PZ&B Staff Combination Memorandum: Town Council and Landmarks Preservation Commission

SUBJECT: COA-24-0005 (ZON-24-0019) 1 S COUNTY RD—THE BREAKERS

MEETING: JULY 10, 2024, TC
JULY 17, 2024, LPC

Proposed drive entrance and main drive off S County Road

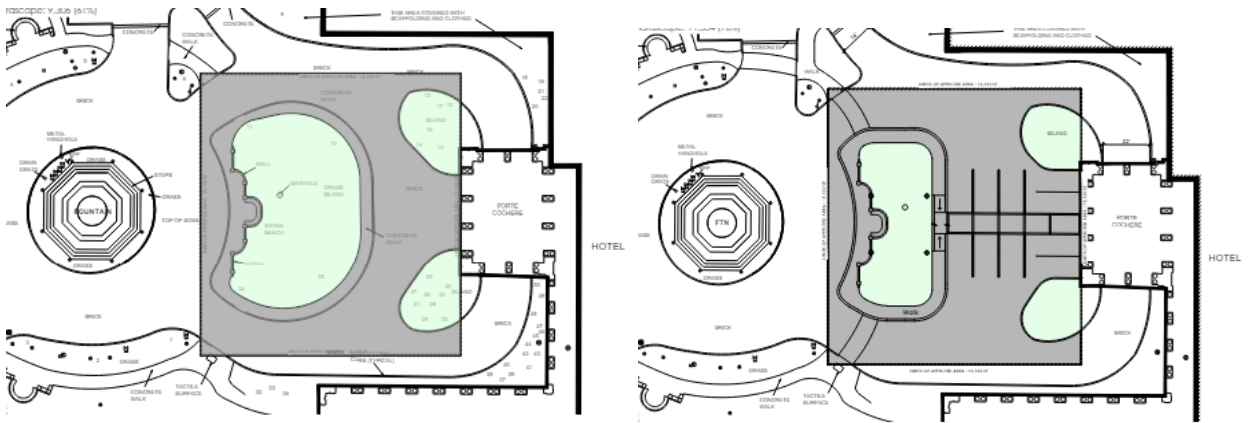
As it pertains to the front entrance (drive entrance from South County Road) the proposed pertinent modifications include:

- Center inner egress lane on main entrance
- Expand Drive aisles to 12' wide lanes and introduce 1' wide mountable curbs with lighting.
- White brick double band to replace mountable curb until the point in which the width of road changes.
- Sidewalk to be relocated south & north of drive new drive aisles in front of palm trees.
- Sidewalks to be adjusted from 6.8' to 5.7' to accommodate existing palms onsite.
- Other landscape changes.
